## IMMEDIATE ACTION REQUIRED BULLETIN

Tuesday, April 17, 2018

**Equipment:** Endura Controller

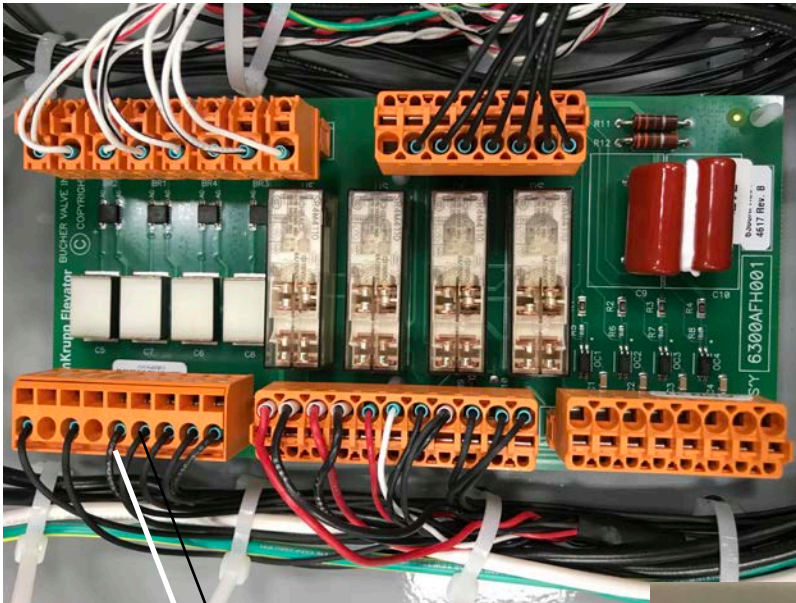
**Problem:** Wiring error on the bucher power supply harness (Con 1 pin 3 on 6300AFH board). While on inspection the car could move at near 70 FPM in the down direction. Reference Gensuite #20126.

**Solution:** Inspect that CON1 Pin 6 is connected to Pin 4 on the bucher power supply. Correct if mis-wired.

Confirm CON1 Pin 6 is connected Pin 4 on power supply.
